RACCOON CREEK SECTION 1

August 7, 2009

Re: Notice of Violation at Raccoon Creek Section 1/Permit #4GC02797*AG

Figure 4: inlet requiring protection

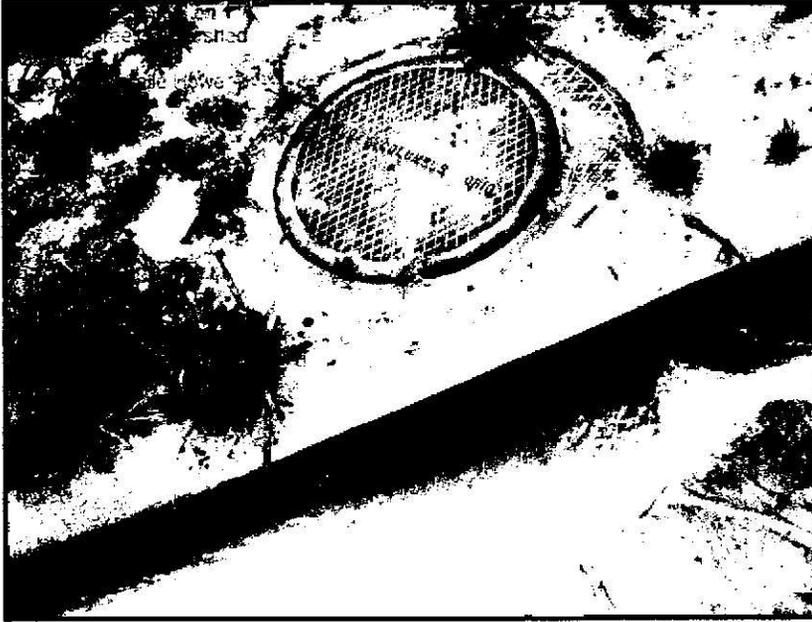
- Several inlet protection devices were noted, but many storm drain inlets remain unprotected and will require installation of protective devices. The inlet protection implemented requires maintenance or reinstallation to ensure a proper functioning condition (See Photo Figures 4 and 5). This general permit states that all sediment controls will be inspected and maintained every seven days or within 24 hours of a precipitation event equal to or greater than 0.5 inches. A log of inspection must be maintained on site for the agency to review.
